RAMP REPORT REGION 2 ADA 2026

Route 7 – Vine Street
Belfast

CR16843

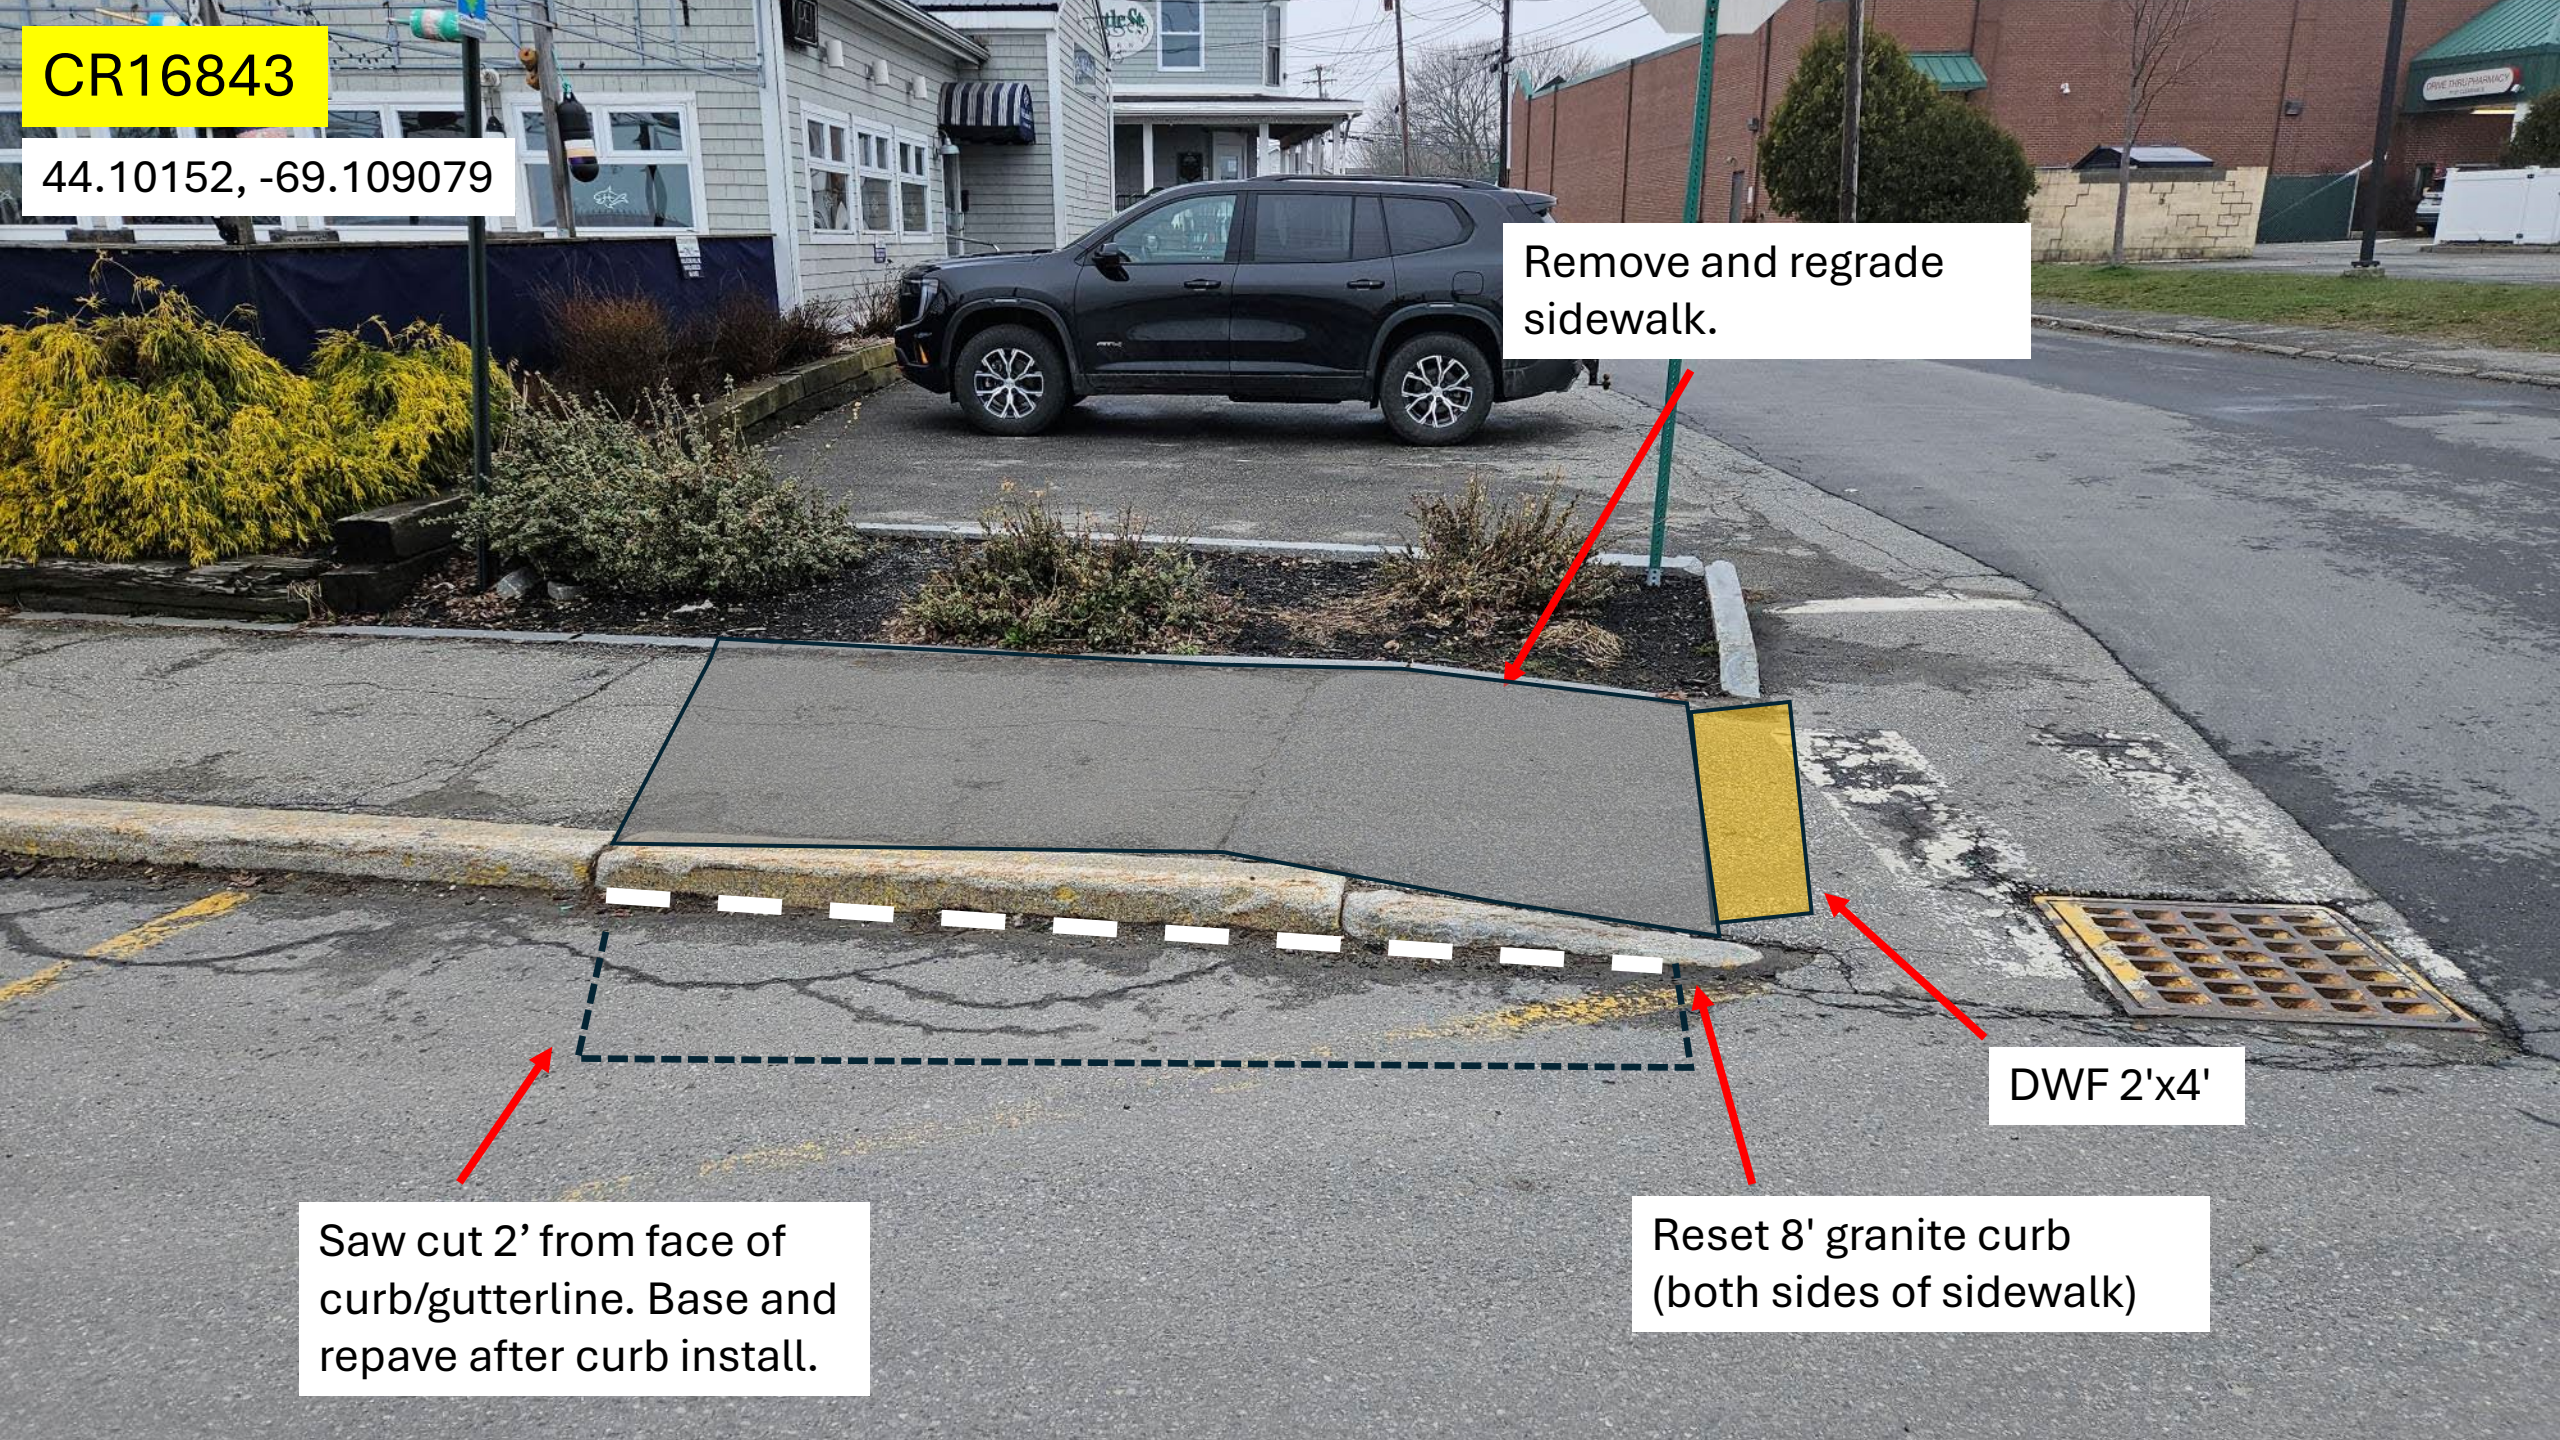
Remove and regrade sidewalk.

DWF 2'x4'

Reset 8' granite curb
(both sides of sidewalk)

Saw cut 2' from face of
curb/gutterline. Base and
repave after curb install.

CR09009

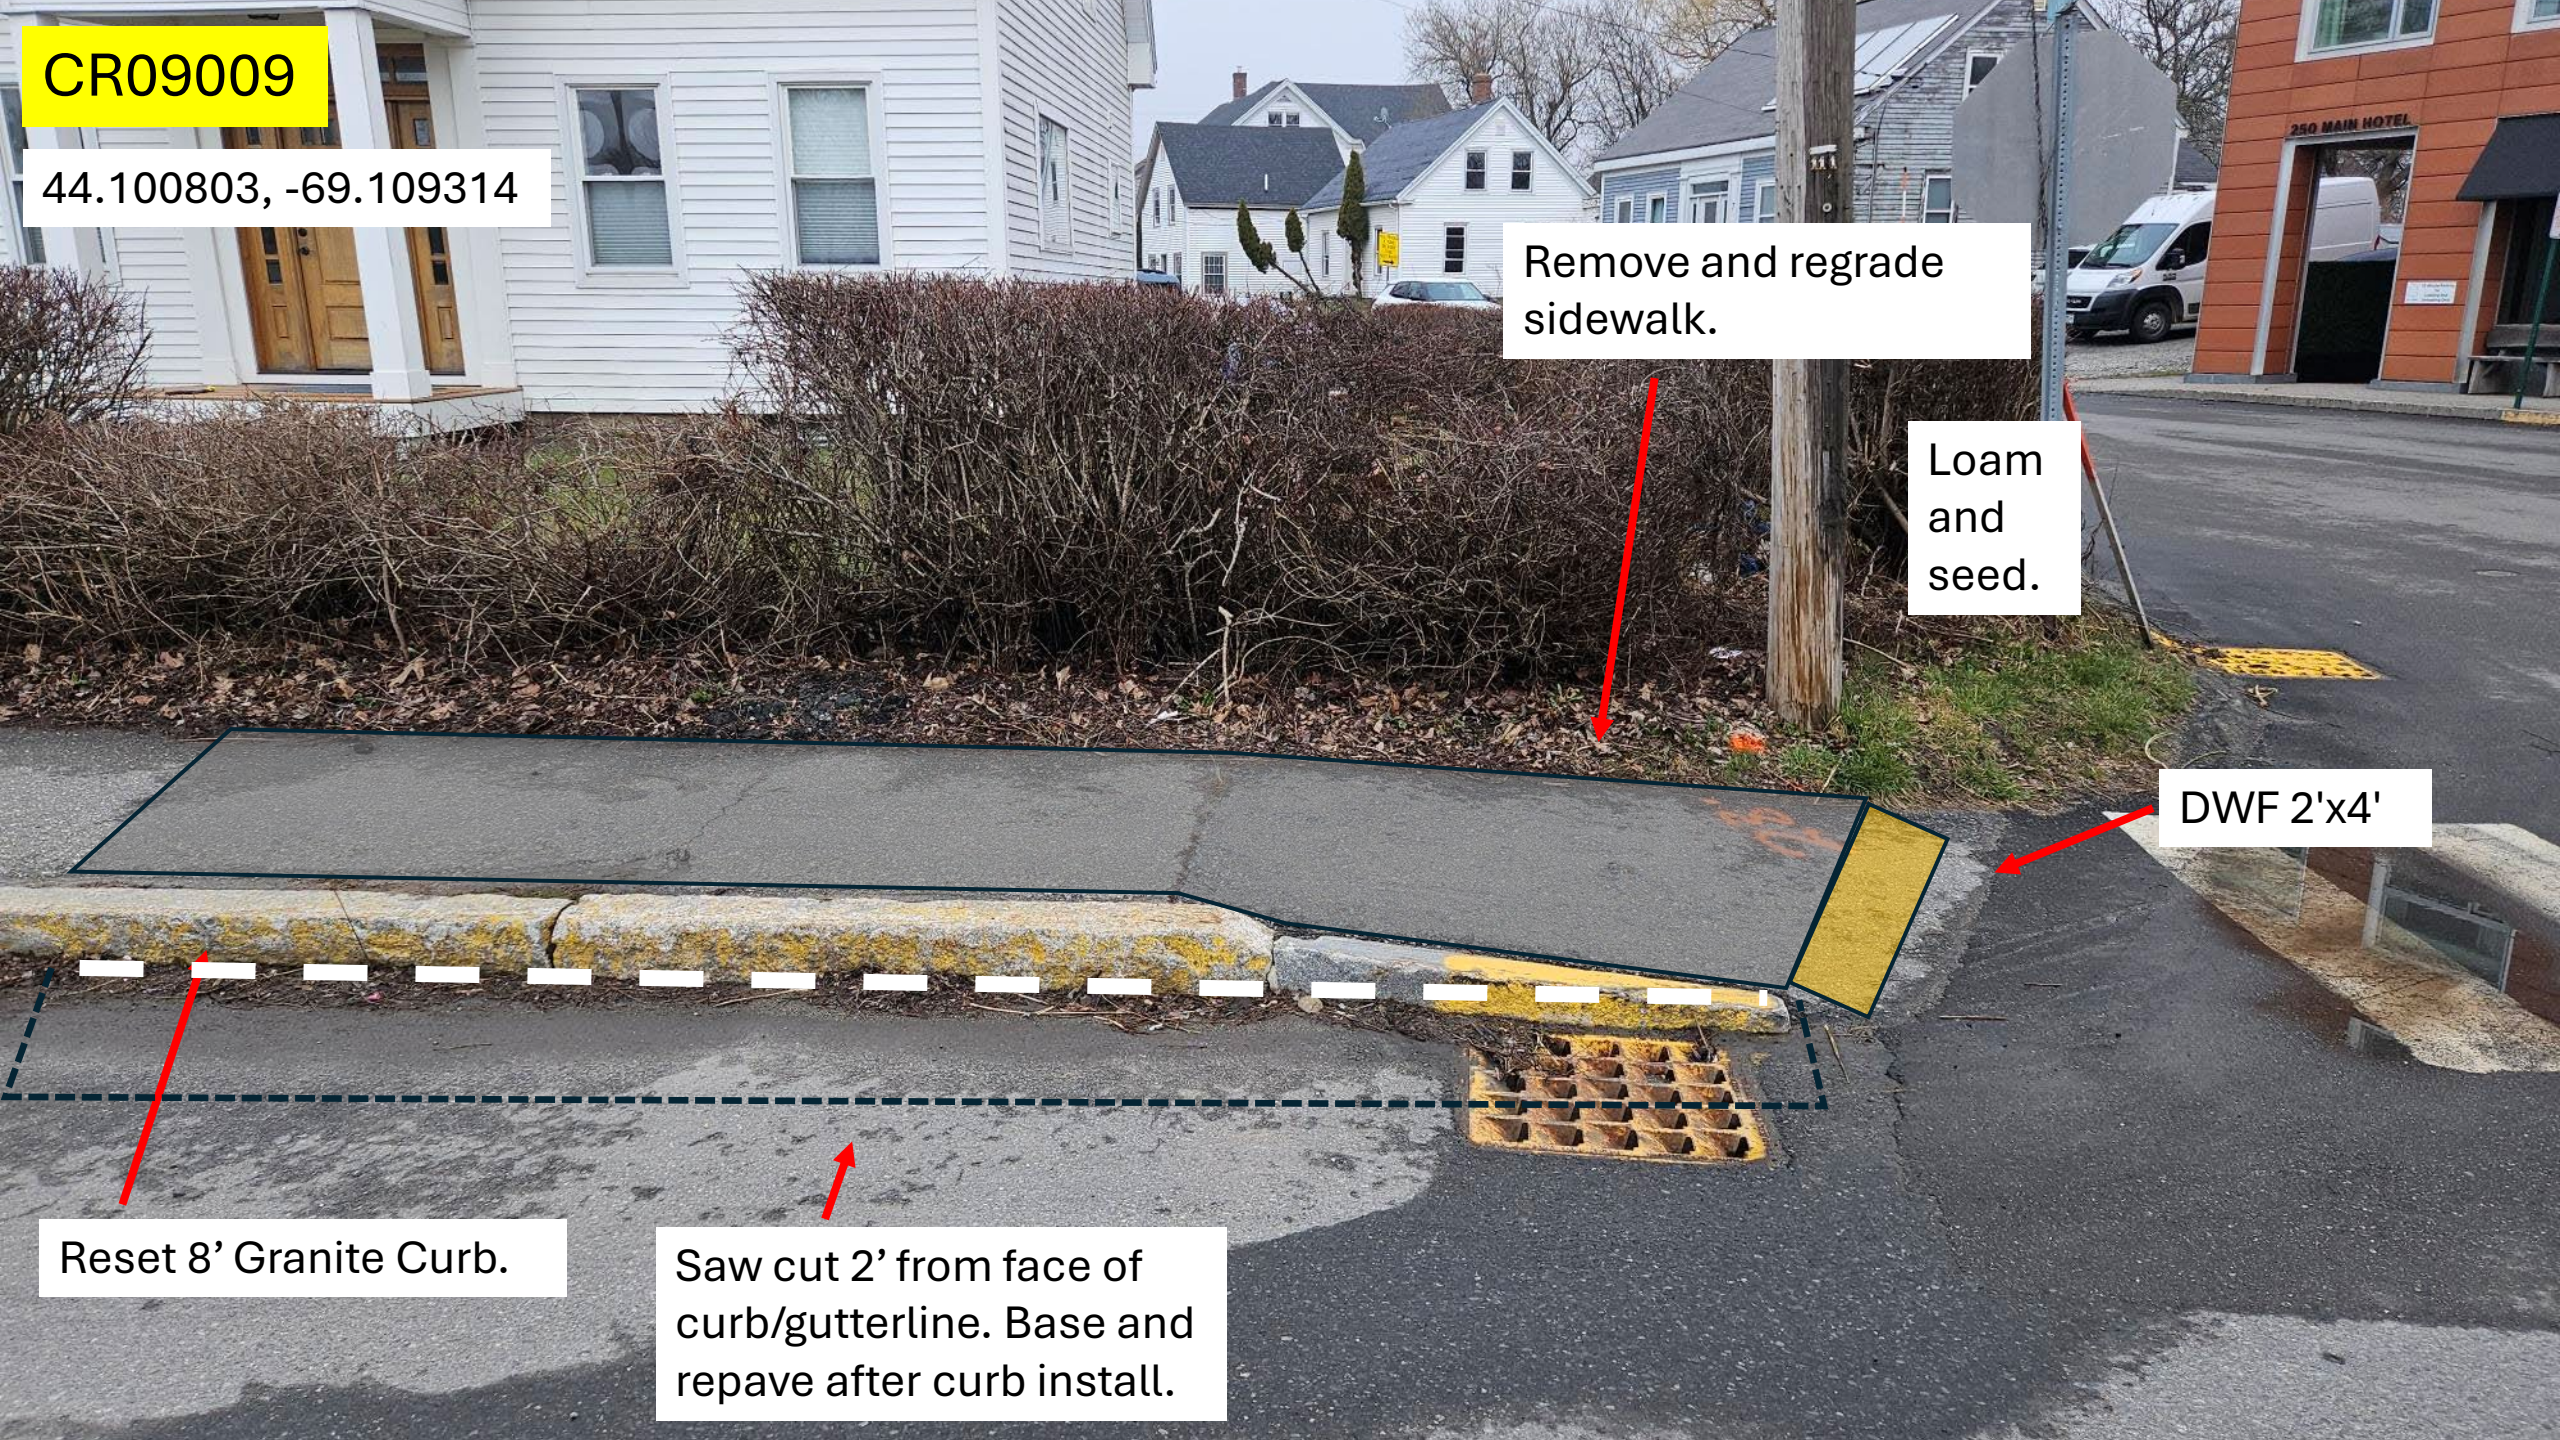
Remove and regrade
sidewalk.

Loam
and
seed.

DWF 2'x4'

Reset 8' Granite Curb.

Saw cut 2' from face of
curb/gutterline. Base and
repave after curb install.

CR09010

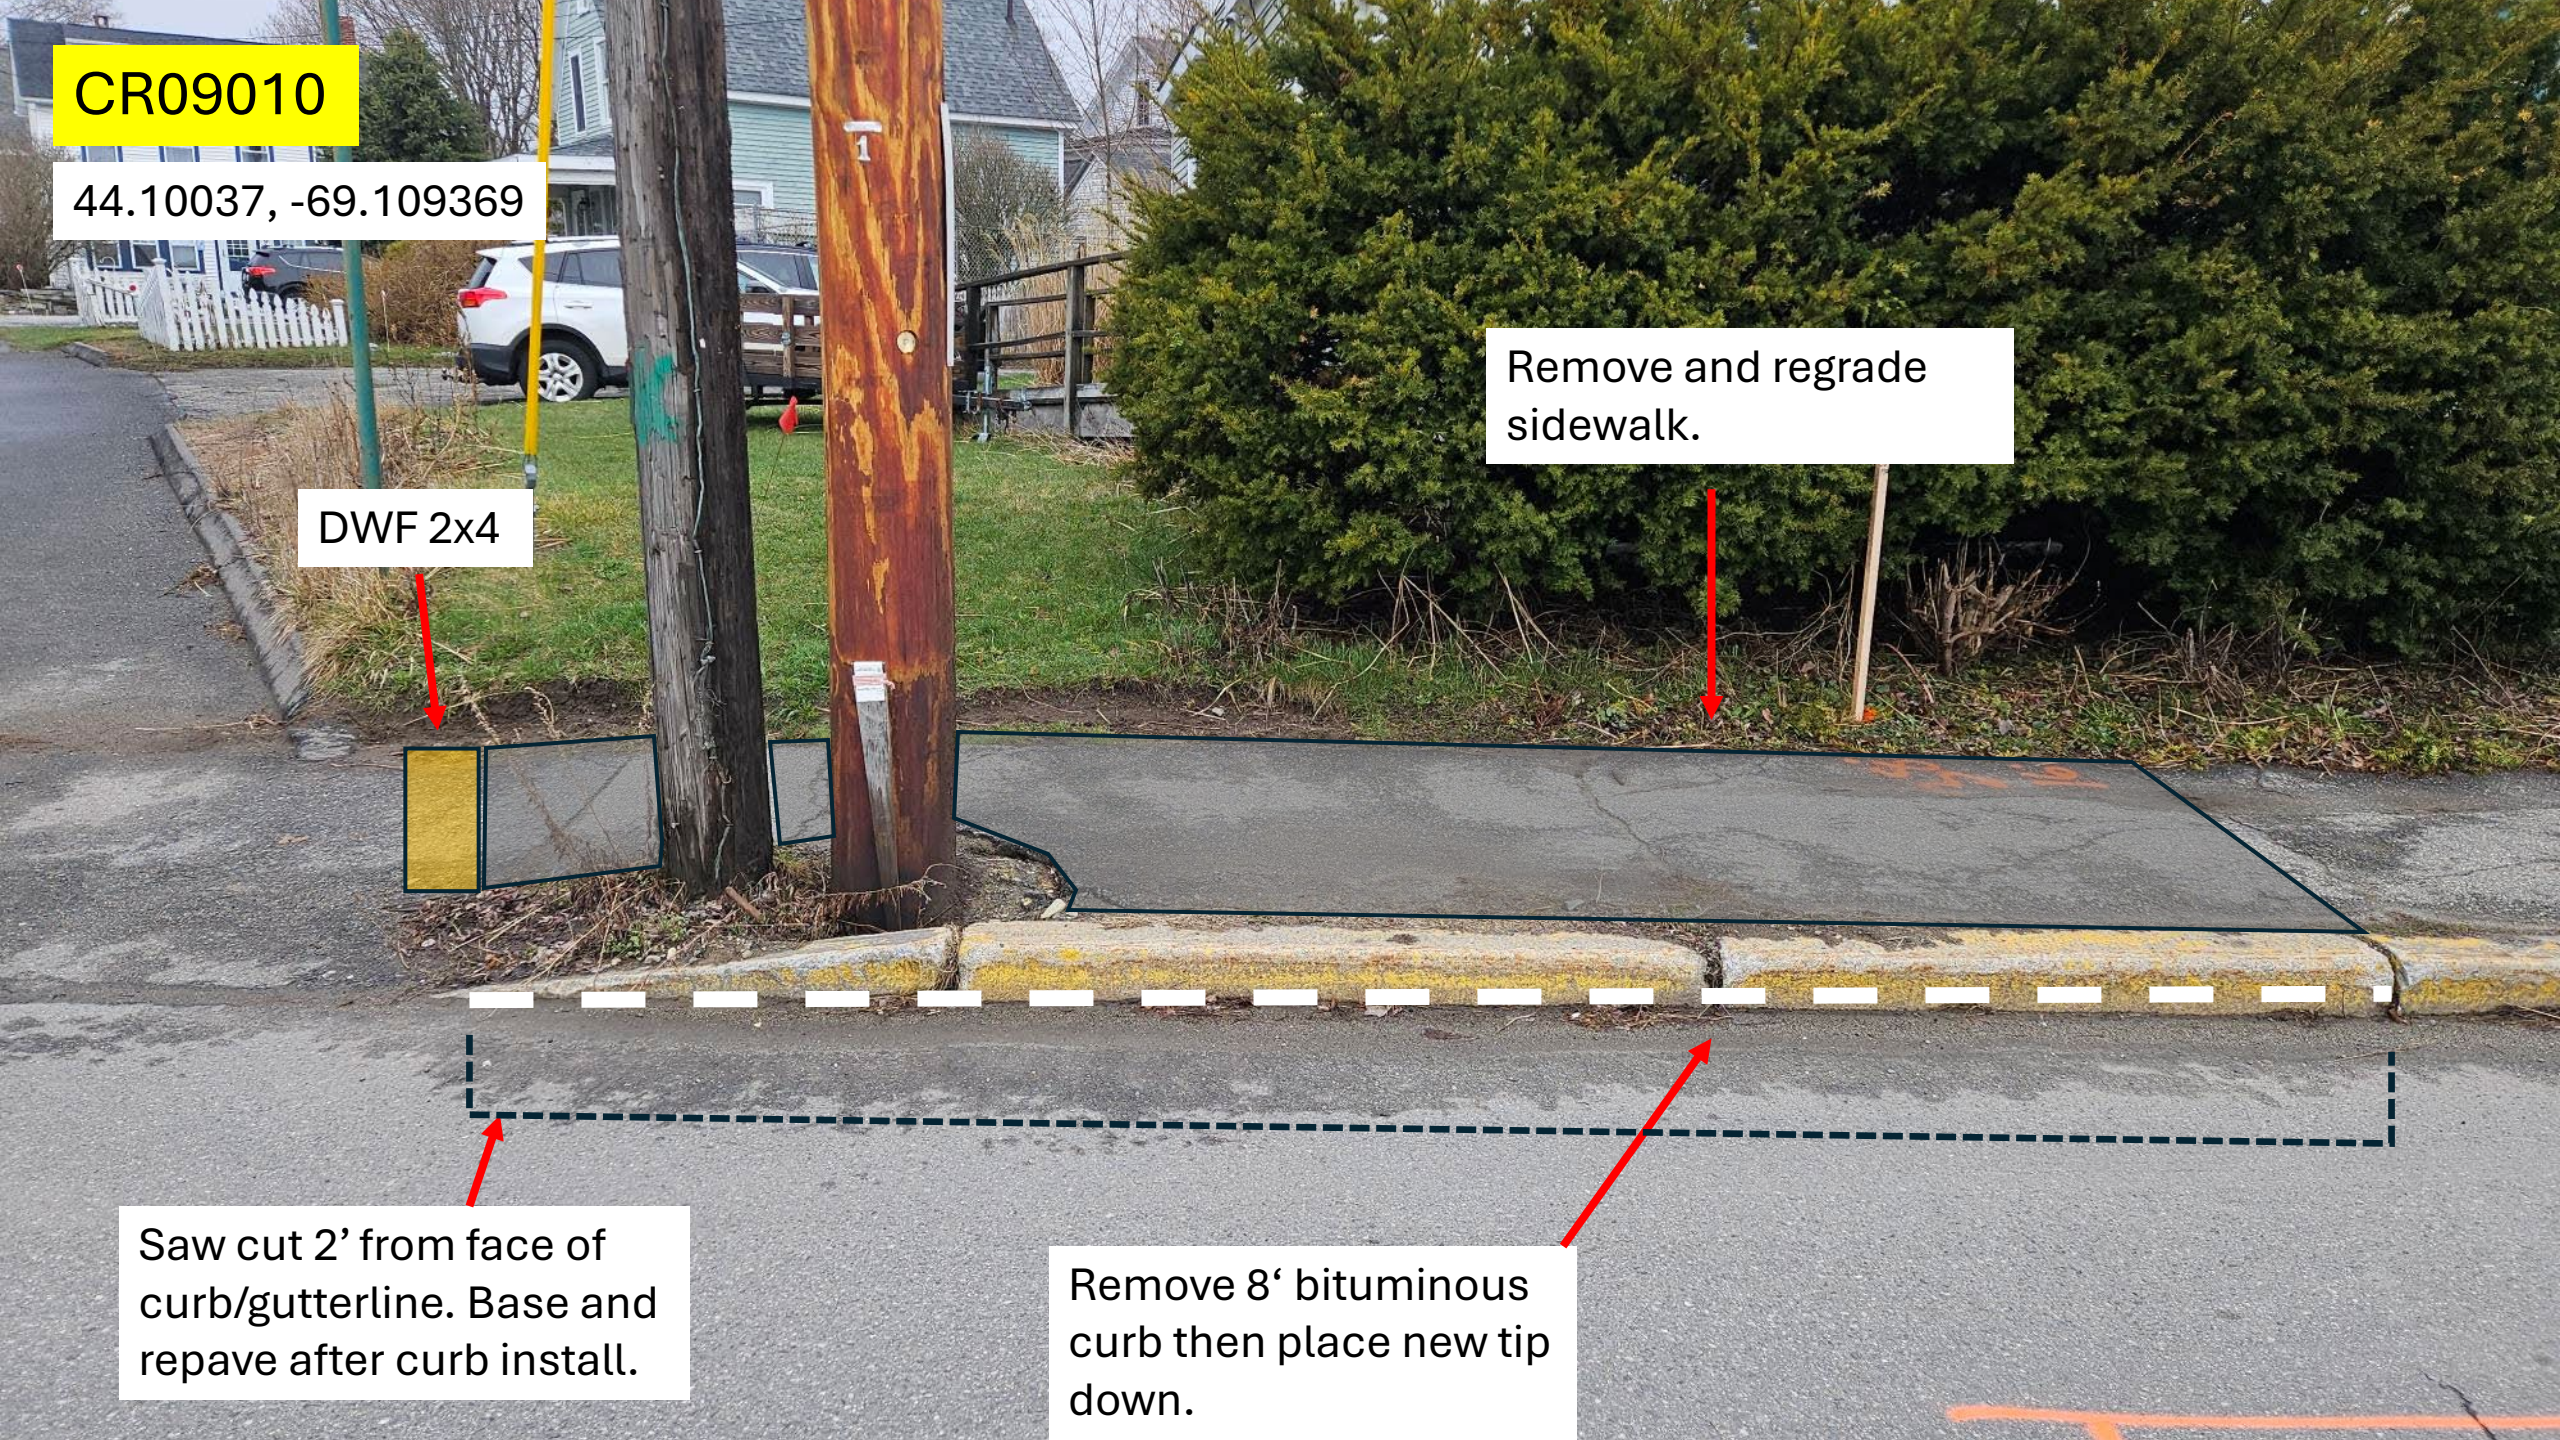
DWF 2x4

Remove and regrade
sidewalk.

Saw cut 2' from face of
curb/gutterline. Base and
repave after curb install.

Remove 8' bituminous
curb then place new tip
down.
